Zoning Staff Report

Date: April 8, 2025 Case Number: ZC-25-004 Zoning Map Amendment & Site Plan Case Manager: **Sandy Michel Owner / Applicant:** Josh Eadie / Bo Trainor Site Location: 521 & 2109 Beach Street and 4021 & 4025 E. 4th St (connection to park) park use easement/ monotony standard Request Cottage-style multi-family- 308 units **Proposed Use:** From: "B" Two-Family & "I" Light Industrial **Request:** To: "PD/D" Planned Development for all uses in "D" High-Density Multifamily plus detached multifamily with development standards for: less than the 30' minimum setback along one-family district, no bufferyard plantings, and to allow fencing along in front of building and along the ROW, no tree canopy preservation requirement; site plan included. Recommendation Land Use Compatibility: Requested change is compatible Comprehensive Plan Map Consistency: Requested change is not consistent (Technical Inconsistency) **Comprehensive Plan Policy Consistency:** Requested change is consistent **Staff Recommendation:** Approval **Zoning Commission Recommendation:** Approval by a vote of 11-0 Table of Contents b. Comprehensive Plan Consistency 1. Project Description and Background 2. Sur

Figure 1: Left Image – FEMA Flood Plain Hazard Area; Right Image – Existing Trees

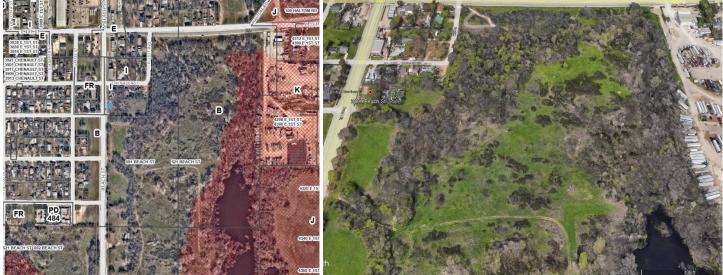
The subject property covers approximately 31.327 acres and is located south of East 1st Street and east of Beach Street. It sits on undeveloped land with numerous existing trees. The surrounding area features a mix of uses, with an established single-family neighborhood to the west and outdoor storage to the east. Adjacent parcels are zoned "B" Two-Family, "I" Light Industrial, "J" Medium Industrial, and "K" Heavy Industrial. Additionally, the area is near a floodplain and the property contains several significant tree types (**Figure 1**). For further information about the impact of zero tree preservation the go to *'Site Plan Comments'* under the section Urban Forestry. Lastly, this case was previously continued at the last Zoning Commission meeting due to incomplete information provided. However, staff has now received the necessary information for a proper review.

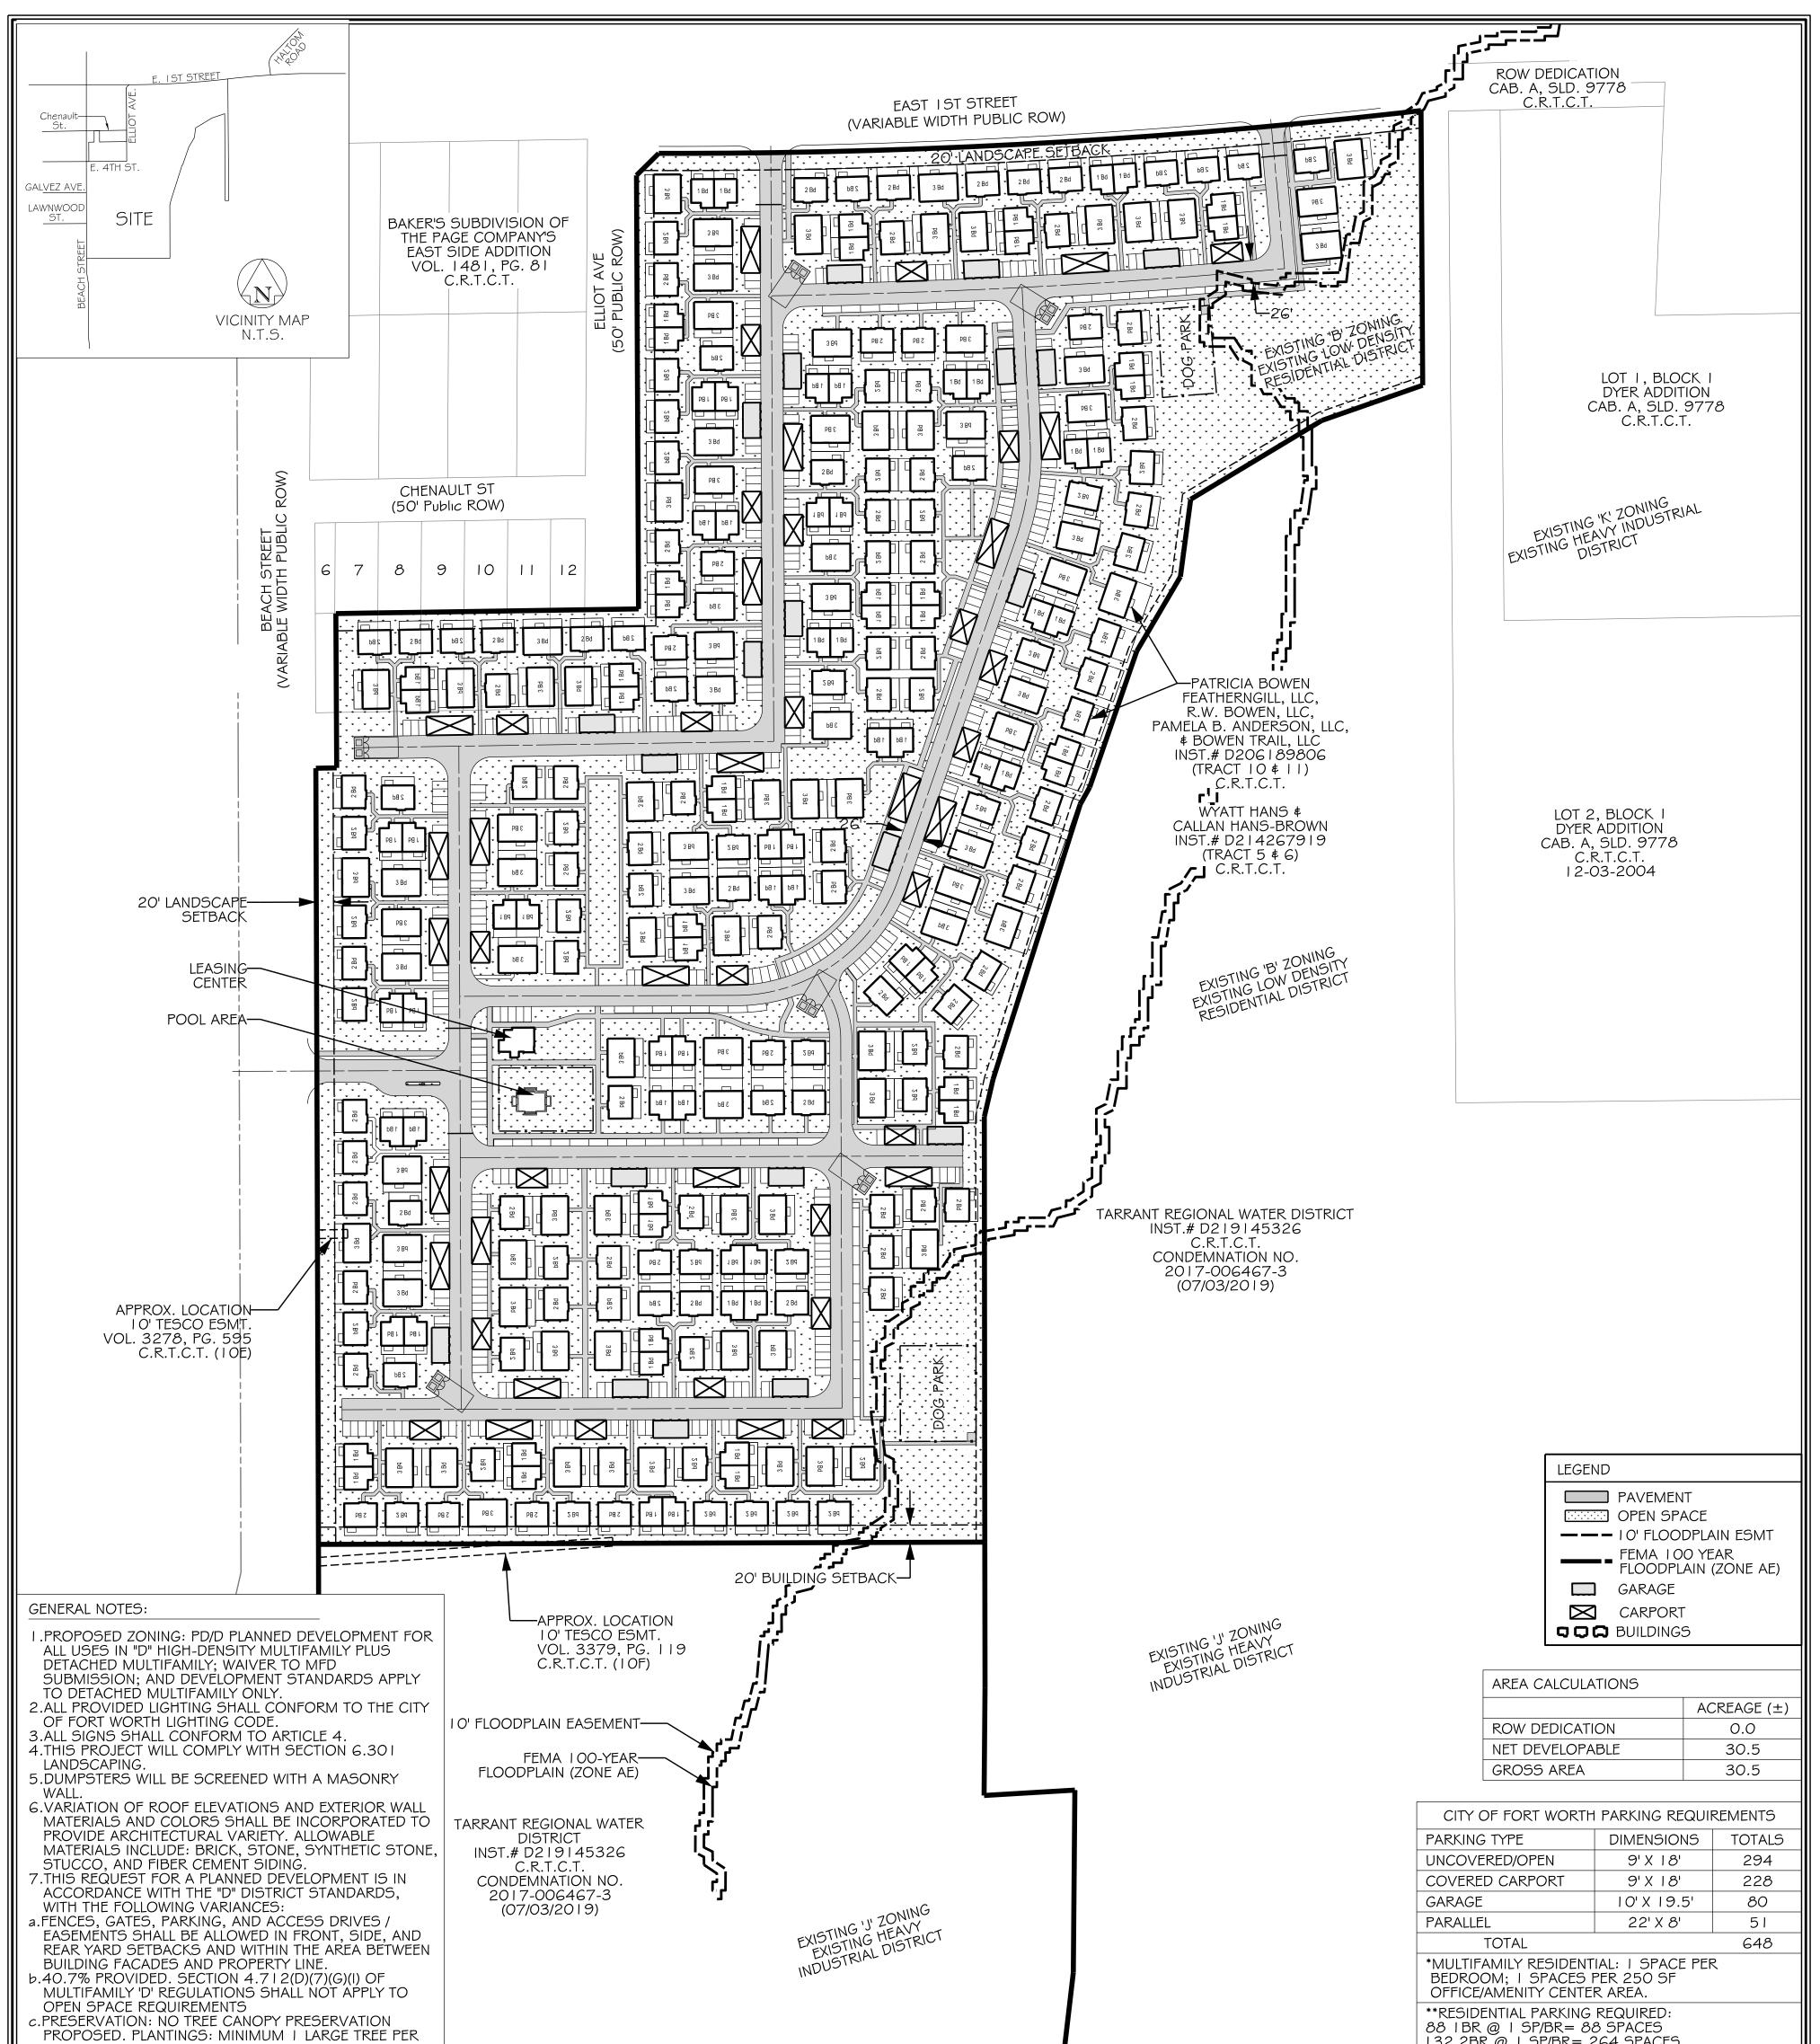
Additionally, concerns have been raised regarding waiver requests for certain development standards, particularly those that could negatively impact the neighborhood to the west and the local environment. Staff initially had concerns about the elimination of bufferyard planting requirements and the 0% tree preservation waiver, given the presence of significant trees on-site. A site visit allowed staff to assess the impact of removing tree plantings and its effect on the existing neighborhood. Notably, Elliot Avenue provides a reasonable buffer from the proposal, though four single-family homes lack the same level of protection on Chenault Street (**Figure 4**).

On the tree preservation, after receiving further clarification from the applicant, staff conducted additional analysis to assess the overall impact of the tree preservation waiver request (see 'Urban Forestry' comments under 'Site Plan Comments'). From the impact study, "Staff recommends approval of the planned development language that would allow for a 0% preservation of canopy..."

• Single family-for rent projects where each unit is not provided a driveway or garage must meet the Fire Code standards for multi-family projects for access points and fire lane width.

- Non-permitted gas well pad site to the east will not impact this site as shown on the plan. Gas well setbacks are applied based on the pad site conditions at the time of building permit application. Section 5706

- Minimum fire lane width for this project type is 26'. All of these fire access roads must be dedicated and named for addressing purposes. Section 503 Fire Lane Specifications

- Additional private hydrants will be required to meet building hose lay. Sections 507 Hydrants
- 2 points of access are provided. Section 503.1.6 Secondary Access One- and Two-Family Residential Developments
